OAKSTONE SUBDIVISION

The purpose of this application is to create a 57-lot subdivision from one parcel.

APPLICATION NUMBER 19 DATE April 6, 2006
APPLICANT Oakstone Subdivision
REQUEST Subdivision

DETAIL SITE PLAN

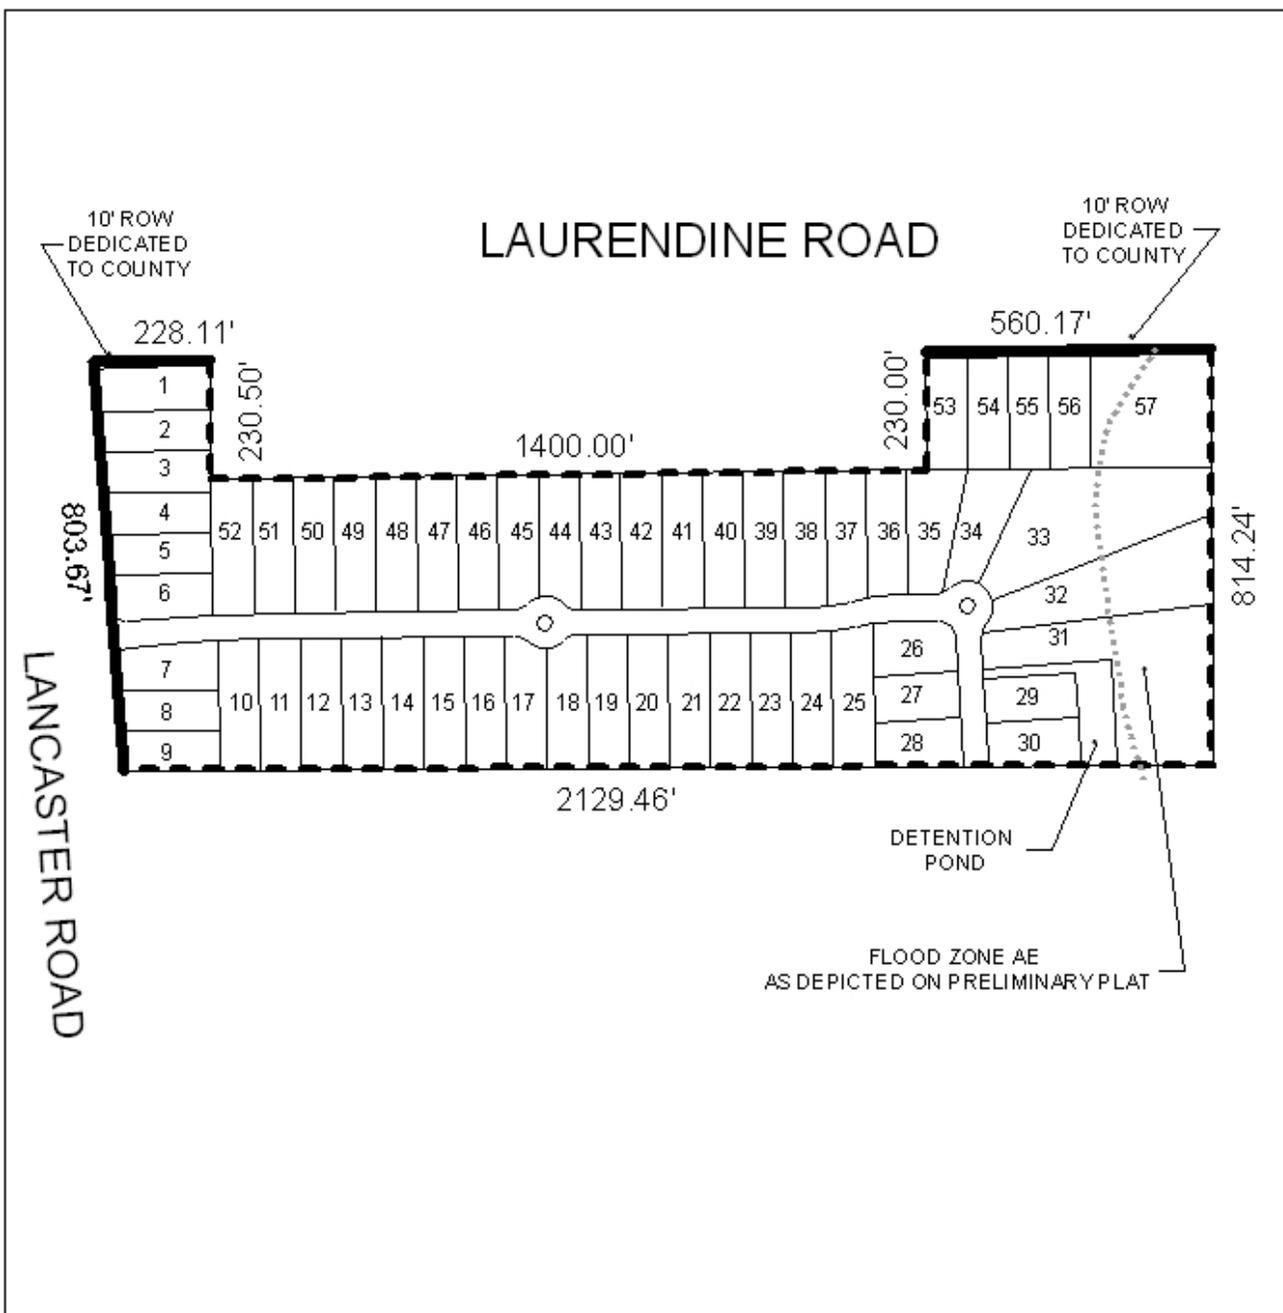
The site fronts onto Lancaster Road and Laurendine Road. Lancaster Road is a minor street, and the existing right-of-way meets the minimum width requirements for minor streets. Laurendine Road, with an existing right-of-way of 80 feet, is a proposed major street, and as such its right-of-way should be 100-feet wide according to the Major Street Plan. Therefore, the dedication of an additional 10-feet, which is depicted on the preliminary plat, should be required along the site's Laurendine Road frontage.

As Laurendine Road is a proposed major street, access management is a concern. The subdivision, as currently designed, depicts lots 1, and 53 through 57 as having frontage on Laurendine Road. Lot 1 also fronts Lancaster Road, thus it should be restricted to having access

only onto Lancaster Road in order to prevent an additional curb cut onto Laurendine Road. Lots 53 through 57 should also be limited in their access to Laurendine Road; lots 53 through 56 should be limited to one curb cut each onto Laurendine Road, while lot 57, due to its 240-foot ± frontage on Laurendine Road, should be limited to a maximum of two curb cuts. The size, design, and location of all proposed curb cuts onto Lancaster and Laurendine Road must be reviewed and approved by the Mobile County Engineering Department.

Oakstone Drive is designed to serve up to 45 lots, and includes one traffic calming device, approximately 850 feet from the entrance at Lancaster Road, and a partial cul-de-sac at its Eastern-most point, before turning South to stub into the property to the South. The landscaped traffic island areas within the traffic calming device and the partial cul-de-sac should be labeled as common areas, and a note should be placed on the Final Plat, if approved, stating that maintenance of the common areas is the responsibility of the subdivision's property owners. Furthermore, the number, location, and design of all traffic calming devices is to be reviewed and approved by the Mobile County Engineering Department.

A detention pond is depicted between lots 29, 30 and 31, with access provided from Oakstone Drive between lots 29 and 31. A note should be placed on the Final Plat, if approved, stating that maintenance of the detention basin common area is the responsibility of the subdivision's property owners.

The applicant is requesting that the 25-foot minimum building setback line be modified for Lots 1, 6, 7 and 26, which are proposed corner lots. The applicant is requesting that for these lots, the "side yard" setback from the street be 20 feet instead of 25 feet, with the front yard setback for all lots remaining 25 feet. A similar request for reduced setbacks, as part of the previous application, was approved by the Planning Commission, however, the Subdivision Regulations require a 25-foot minimum building setback line from all road frontages. Due to the requirements of the Subdivision Regulations, any changes to the required minimum building setback lines must be addressed by the Planning Commission instead of staff. All setback lines must be depicted on the Final Plat, if approved.

The eastern portion of the site appears to be within the FEMA designated "100-year" floodplain of Muddy Creek, and wetlands associated with the creek may occur on a portion of the site. According to County Engineering staff, it appears that no detailed floodplain or floodway determination has been made for this site, therefore, a study may be required. The presence of wetlands and floodplains indicate that the area may be environmentally sensitive; therefore, the approval of all applicable federal, state and local agencies would be required prior to the issuance of any permits or commencement of any land disturbing. It should also be noted that detention ponds cannot be located within the 100-year floodplain, therefore the applicant should consult the Mobile County Engineering staff to ensure that the detention pond is appropriately located.

Based upon the proceeding, the plat is recommended for Tentative Approval, subject to the following conditions: 1) the dedication of 10-feet along the site's Laurendine Road frontage, as depicted on the preliminary plat; 2) placement of a note on the Final Plat stating that Lot 1 is restricted to access only onto Lancaster Road, lots 53 through 56 are limited to one curb cut each onto Laurendine Road, and lot 57 is limited to a maximum of two curb cuts, with the size, location and design of all proposed curb cuts to be approved by the Mobile County Engineering Department; 3) placement of a note on the Final Plat stating that traffic calming devices are to be provided, as approved by the Mobile County Engineering Department; 4) labeling of traffic calming device landscape areas as common areas; 5) placement of a note on the Final Plat stating that the maintenance of common areas and the detention pond is the responsibility of the subdivision's property owners; 6) depiction and labeling of the minimum building setback line from the dedicated rights-of-way, with a waiver of Section V.D.9. to allow "side yard" setbacks of 20 feet for proposed Lots 1, 6, 7 and 26, and 25 feet for all other lots and the "front yards" of Lots 1,6,7 and 26; 7) placement of a note on the final plat stating that any lots which are developed commercially and adjoin residentially developed property must provide a buffer, in compliance with Section V.A.7. of the Subdivision Regulations; 8) dedication and construction of roads to Mobile County standards; 9) approval of all applicable federal, state and local agencies required prior to the issuance of any permits or land disturbance; and 10) verification with Mobile County Engineering Department that proposed detention pond is located outside of the 100-year floodplain.
